How to Replace MX4 with MX4-R2

Please observe the wire changes below when exchanging the MX4 with the MX4-R2.

Wiring Changes

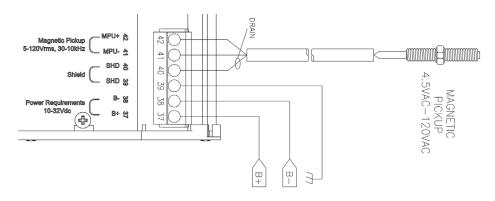
- 1. Carefully unplug the terminal block connectors from the MX4 board and remove it from the DIN rail. Leave the wires connected to the old terminal plugs for now.
- 2. Mount the MX4-R2 on the DIN rail.
- 3. Carefully remove each wire from the MX4 connector and attach them to the MX4-R2 connector matching terminal numbers from the old to the new terminal. The numbers match up to the original MX4 pin function.

NOTE: The MX4 terminal blocks are not interchangeable and will not be used with the MX4-R2 board.

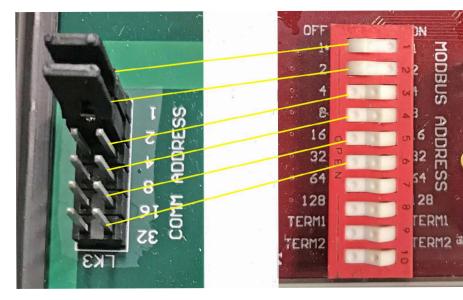
4. Match the LK3 Comm Address jumper positions on MX4 to the Modbus Address position 1 thru 6 on the MX4-R2. If a jumper is installed, position the switch to the Closed position (toward the Modbus Address) text.

MX4; LK3 is shown with jumpers in position 1 and 2.

MX4-R2; Set position 1 and 2 Closed with rocker down on the right side. Set position 3-6 Open with the rocker down on the left side.

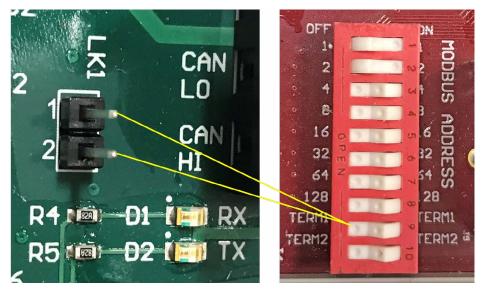
5. The LK1 Term is located near terminal 52 under the cover of MX4. Match its jumper position to the Modbus Address position 9 on the MX4-R2. If jumper was installed in LK1, set position 9 to the Closed position. If its without a jumper, set position 9 to the Open position.

MX4; LK1 TERM shows no jumper is used.

MX4-R2; Set position 9 to Open with rocker down toward left side.
